Summary of the Proposed Central Delta Intakes Analysis

3/18/2000

Figure 1 - Central Delta Intakes Options and Components (as Presented)

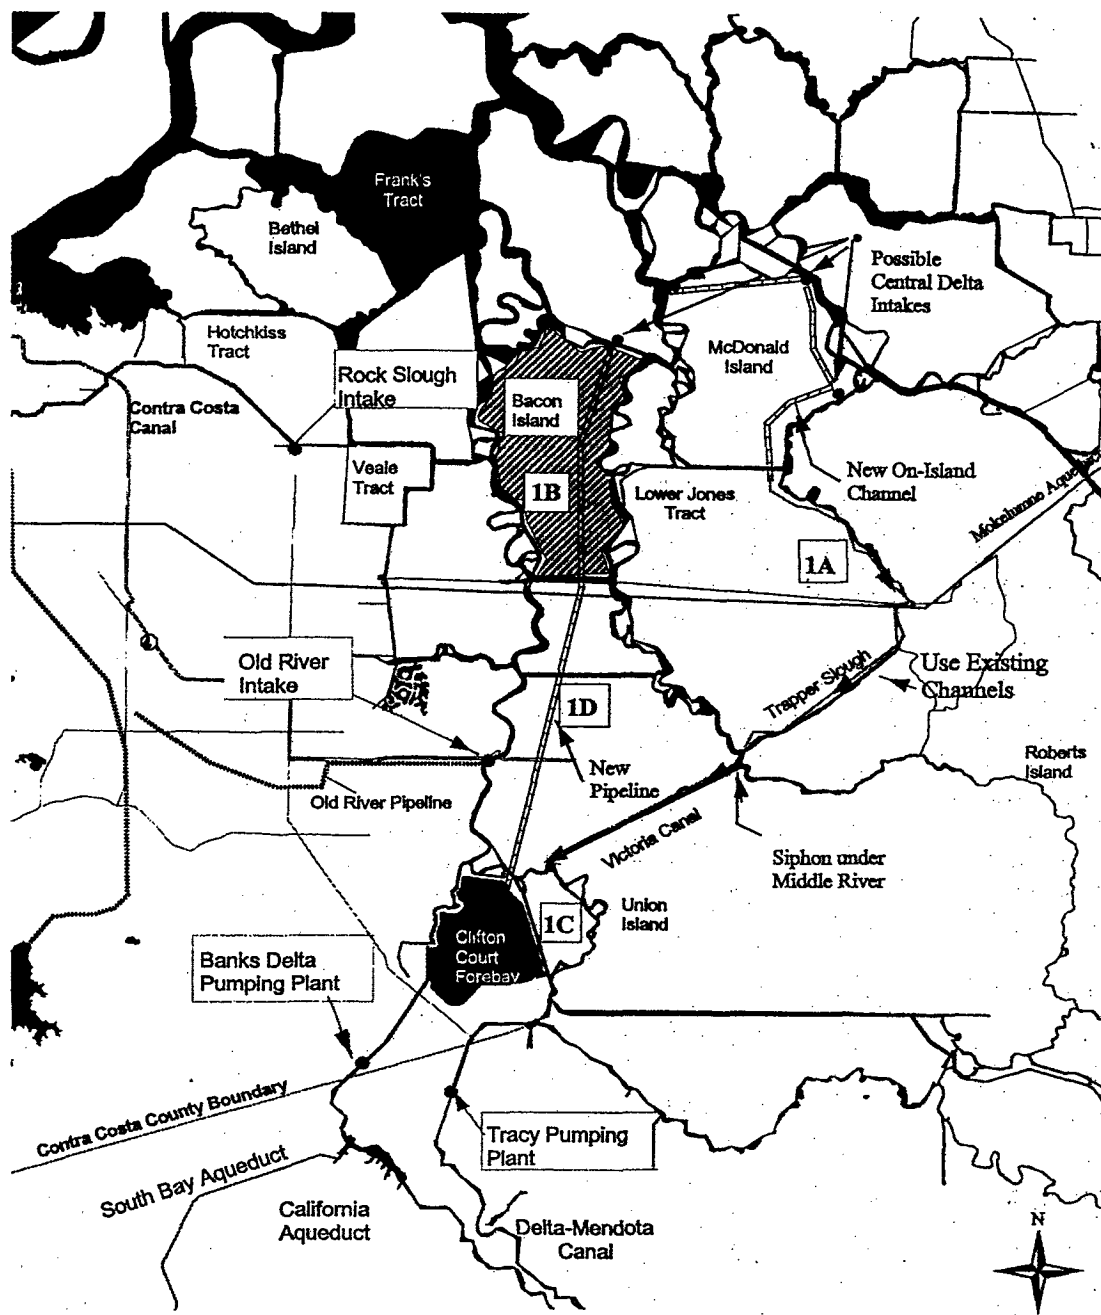
The McDonald Island Intake will be very difficult to implement as presently outlined in the proposal. Some elements of this portion of the proposal however are being looked into. The South Delta Improvements Program has expanded the scope and analysis of various project components to include combinations of various barrier configurations, dredging alternatives, consolidation of agricultural diversions, and on-island water distribution systems that may serve a portion of South Delta needs (for example, the on-island distribution system being considered in the SDIP could pump water from Clifton Court Forebay and serve a portion of the areas most affected by not placing a Grantline barrier).

The SDIP has not considered a no-barrier alternative that distributes water to all South Delta lands via an extensive on-island distribution system as presented in the Central Delta Intake proposal (the McDonald Island intake side of the proposal). An extensive on-island distribution system that would divert from an isolated diversion channel (i.e. screened), would have to serve approximately 100,000 acres distributed over several Delta islands. A number of issues make implementation of this component difficult as a Stage 1A action including:

- extensive timeline to stage and construct this system;
- water rights issues;
- high costs (up to \$500 million); and,
- cooperation of landowners to implement this system

Therefore, since there are functionally a number of alternatives that will improve South Delta water quality and diversion issues, this component of the proposal does not solve the problems in the South Delta.

A proposed future phase of the McDonald Island diversion included a connection to the SWP/CVP export facilities. It was determined that having only one connection to the Central Delta would be functionally equivalent to two since both intakes would be from the Central Delta. Therefore, a connection from a storage island would serve this purpose better. Consolidating two intake channels into one further questions the need to serve the South Delta needs from the Central Delta diversion.
